Access Compliance Report

Public Rights-of-Way

(Curb Ramps)

Intersection ID: 10025962	Main Street: ELM_LN	Cross Street: N/A	Location: NW
ADA ID: C24F77FE6950	Ramp Type: PerpDiag	Initial Pass/Fail: Fail	Overall Compliance: No
		Severity Score: 25

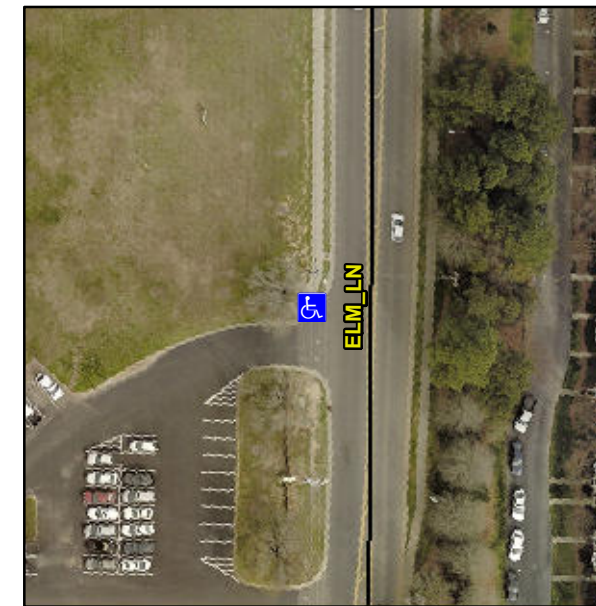
Not Found, R304.2.2, R304.5.3

Compliance	Description	Data	Compliance	Description	Data
N/A	Ramp Length (in)	108.0	No	Ramp Slope (%)	8.5
Yes	Ramp Width (in)	48.0	No	Ramp XSlope (%)	6.3
N/A	Flare Type LT	N/A	N/A	Flare Type RT	N/A
N/A	Flare Slope LT (%)	N/A	N/A	Flare Slope RT (%)	N/A
N/A	Flare Traversable LT?	N/A	N/A	Flare Traversable RT?	N/A
N/A	Landing Length (in)	N/A	N/A	DWS Provided?	N/A
N/A	Landing Width (in)	N/A	N/A	DWS Contrast?	N/A
N/A	Landing Slope (%)	N/A	N/A	DWS Length (in)	N/A
N/A	Landing X Slope (%)	N/A	N/A	DWS Full Width?	N/A
N/A	Landing Curb? (Y/N)	N/A	N/A	DWS Offset (in)	N/A
N/A	Shared Landing?	N/A			
N/A	Gutter Ponding?	N/A	N/A	Gutter Slope (%)	N/A
N/A	Gutter Lip Ht (in)	N/A	N/A	Gutter X Slope (%)	N/A
N/A	Painted X Walk1?	No	N/A	Painted X Walk2?	No
	X Walk 1 Direction	To SE		X Walk 2 Direction	To NE
N/A	X Walk 1 Width (in)	N/A	N/A	X Walk 2 Width (in)	N/A
	X Walk 1 Slope (%)	7.1		X Walk 2 Slope (%)	5.0
	X Walk 1 X Slope (%)	0.5		X Walk 2 X Slope (%)	6.3

Remove & Replace Curb Ramp With Two New Directional Ramps or Equivalent.
